## DEVELOPMENT APPLICATION ASSESSMENT REPORT

<b>ITEM No.</b>	
<b>FILE No.</b>	DA 215/2011/1
<b>PROPERTY DETAILS</b>	88-96 Newcastle Street, Rose Bay
<b>Lot &amp; DP No.:</b>	LOTS: 14, 15, and 16 SEC: D DP: 5092 LOT: 1 SEC: DP: 92579 LOT: 1 SEC: DP: 1079086
<b>Side of Street:</b>	East
<b>Site Area (m<sup>2</sup>):</b>	3470.7m <sup>2</sup>
<b>Zoning:</b>	Residential 2(b)
<b>PROPOSAL:</b>	Staged development consisting of the following: <ul style="list-style-type: none"><li>- Demolition:</li><li>- Stage 1 - Demolition of the existing dwelling-house and ancillary structures at 88 Newcastle Street</li><li>- Stage 2 - Demolition of the existing dwelling-house and ancillary structures at 94 Newcastle Street; demolition of the former St Paul's Anglican Church and former Parish Hall (Possums Pre-School) at 96 Newcastle Street; removal of existing landscaping and trees</li><li>- Retention of the existing Greek Orthodox Church at 90-92 Newcastle Street</li></ul> Construction: <ul style="list-style-type: none"><li>- Stage 1 - Construction of a new 34 place Childcare Centre</li><li>- Stage 2 - Construction of a new 4 storey residential flat building (RFB) comprising of 20 residential units with

#### Unit 3, 453 Old South Head Road:

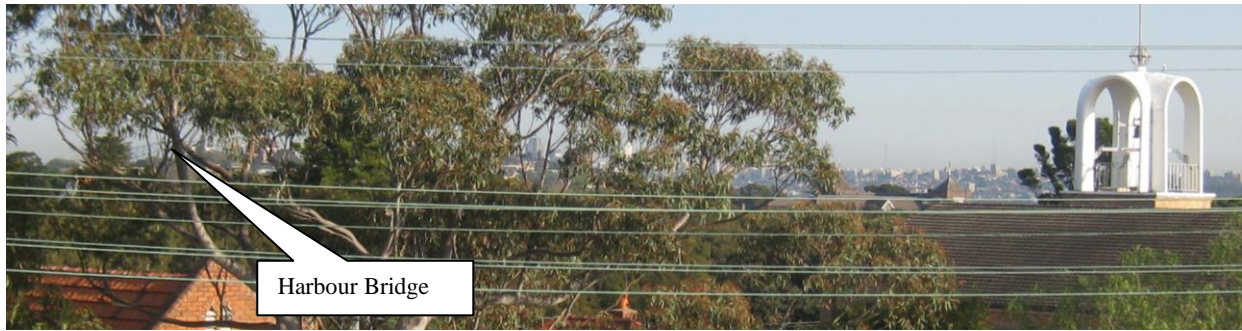
The proposal will reduce or remove the views of the City Skyline, Harbour Bridge and North Sydney. Given that the proposal will substantially remove or reduce the iconic views available from a standing position, across a front boundary, the view loss is considered to be moderate-severe.

The proposal will remove the views of The Royal Sydney Golf Club from a standing position, across a front boundary. The view loss is considered to be moderate.

The proposal will remove the views of Sydney Tower and partial views of the City Skyline. Given that the proposal will remove the iconic views available to unit 3, from a standing position across a front boundary, the view loss is considered to be moderate-severe.
